VariStroke-I Actuator Change Announcement

Change

Figure 1. Service Tool – Internal Status Screen

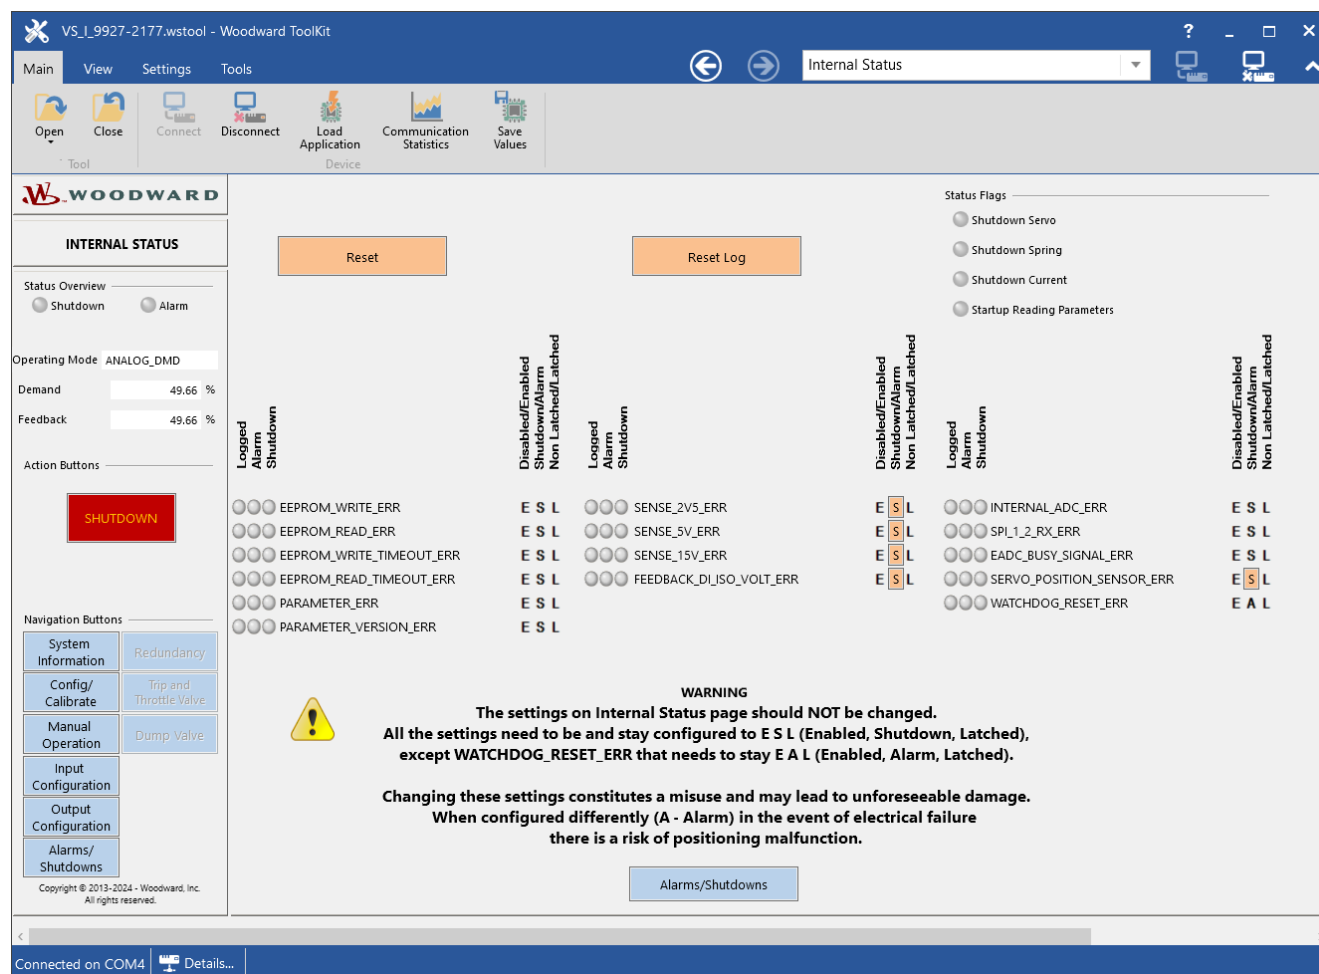
Note that Woodward's latest VariStroke-I Customer Service Tool 9927-2177 revision M or greater must be used with this new VariStroke firmware to access the above listed settings. The configuration method is provided within Customer Service Tool manual 35148 revision C or greater.

The settings on the Internal Status page should NOT be changed. All settings must remain configured to E S L (Enabled, Shutdown, Latched), except WATCHDOG_RESET_ERR, which should remain E A L (Enabled, Alarm, Latched).

Changing these settings constitutes a misuse and may lead to unforeseeable damage. When configured differently (A- Alarm), there is a risk of position malfunction in the event of electrical failure, including unintentional full-open position of the controlled valve.
